PLANNING REPORT

TO: Phil Kern
FROM: Alan Brixius
DATE: December 9, 2009
RE: Delano – MAJG Property – Auto Repair Conditional Use Permit
FILE NO: 432.07 – 09.19

PROPOSED SITE PLAN AND
 CERTIFICATE OF SURVEY FOR
MARC GILLET
 IN THE NE 1/4 OF SEC. 13-118-25
 WRIGHT COUNTY, MINNESOTA

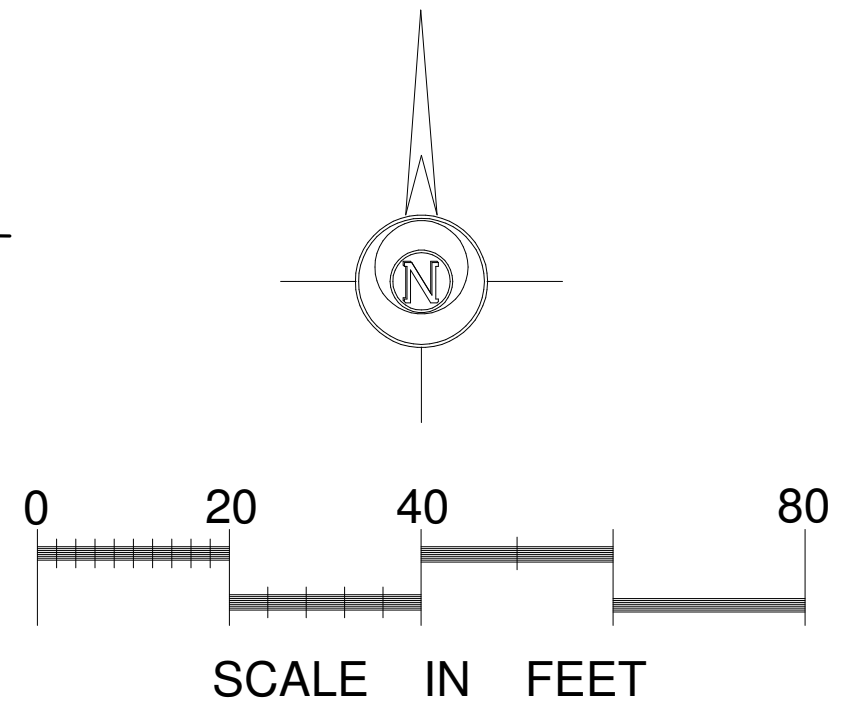
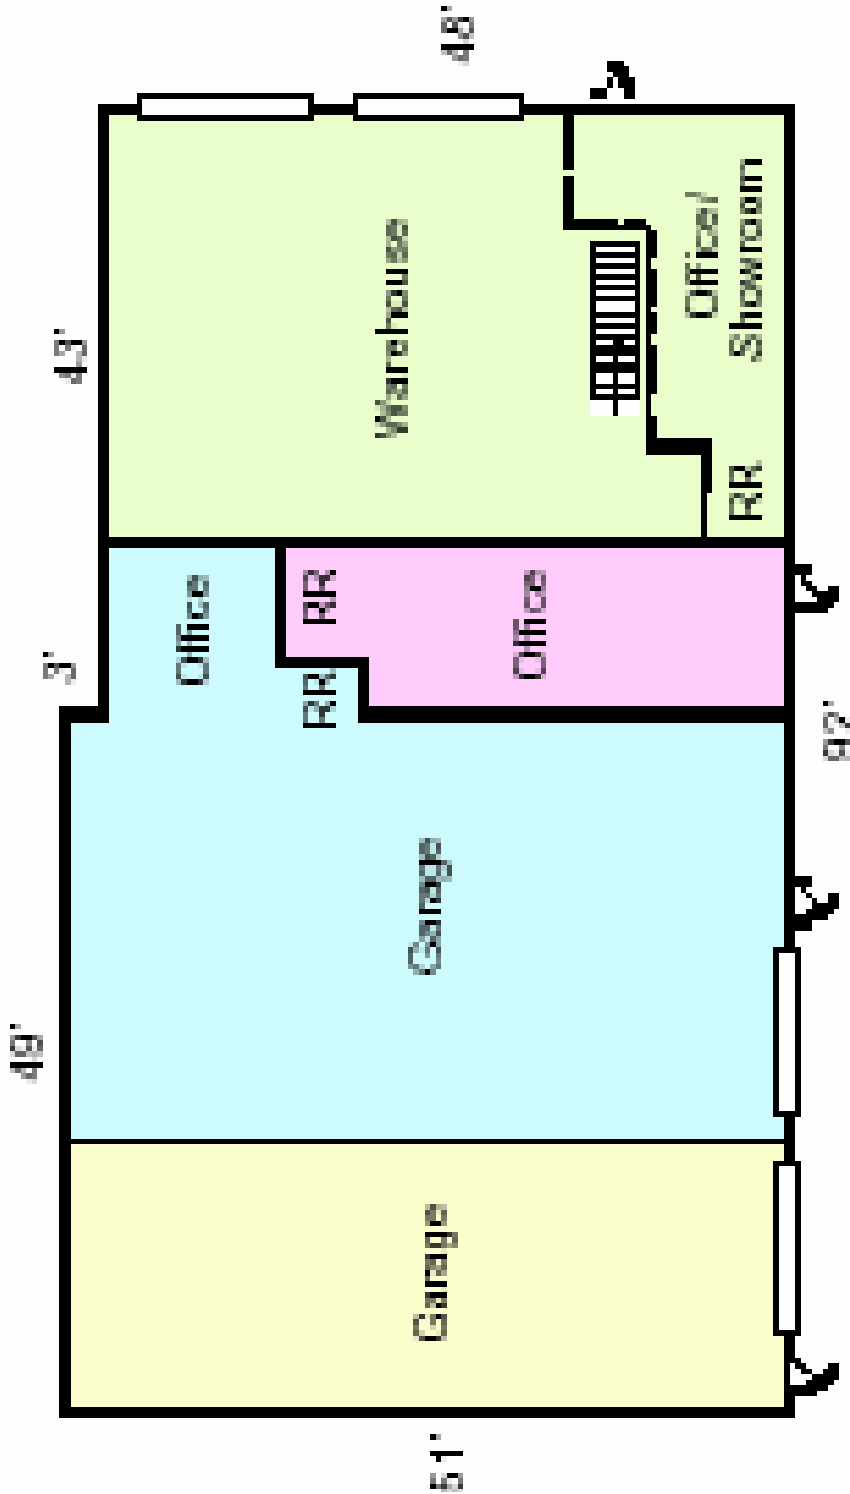
The site has historically had a compacted gravel parking lot to serve this building. This non-conforming condition is being corrected with this application. The applicant's site plan illustrates a bituminous surface parking lot.

A B-612 curb is shown along the west, north and south boundaries of the lot with a surmountable curb along the east parking lot edge. The surmountable curb is intended to accommodate future parking lot expansion without the need to replace the curb.

1. The certificate of survey refers to 9th Street. This street should be identified as 7th Street south of TH 12 and Tiger Drive north of TH 12.
2. The proposed improvements include paving an existing parking surface. The existing surface is currently impervious although not paved. The pavement area is less than one acre. Although water quality improvements are not required, cost-effective BMPs should be implemented where feasible.
3. The north two-thirds of the parking lot drains north and west to a proposed catch basin. The proposed catch basin will connect to an existing catch basin in the curb line of 7th Street.

- a. This connection is acceptable
 - b. The connection storm sewer must be a minimum of 12-inches in diameter.
 - c. The storm sewer material must be RCP or PVC SDR 35.

- d. The catch basin should include a two foot sump to trap sediment from the parking lot.
4. The south one-third of the parking lot drains to a proposed swale along the south property line. The swale drains to a flared end section (FES) and storm sewer system under 7th Street.

- a. This connection is acceptable
 - b. The graded swale shall include a one foot deep depression prior to the (FES) to trap sediment.
 - c. The swale shall be seeded and protected from erosion.

5. A maintenance agreement may be considered to assure long-term maintenance of the manhole sump and the swale. This agreement would be similar to the agreement created for the Harley Davidson sump manholes.

6. According to the certificate of survey, it appears that a small portion of the 7th Street sidewalk encroaches onto this property. We have reviewed the dedicated easements and all sidewalk is within ROW or easement. Certain easements are not reflected on this certificate of survey.

Trash Enclosure. The site shows a trash enclosure location at the south end of the building. The location is acceptable. The applicant must provide a trash enclosure elevation detail that demonstrates compliance with City construction standards.

5. The applicant shall implement the City Engineer comments found in this report pertaining to the site survey and site grading and drainage.
6. The applicant shall provide detailed construction drawings for the trash enclosure for approval by City staff.
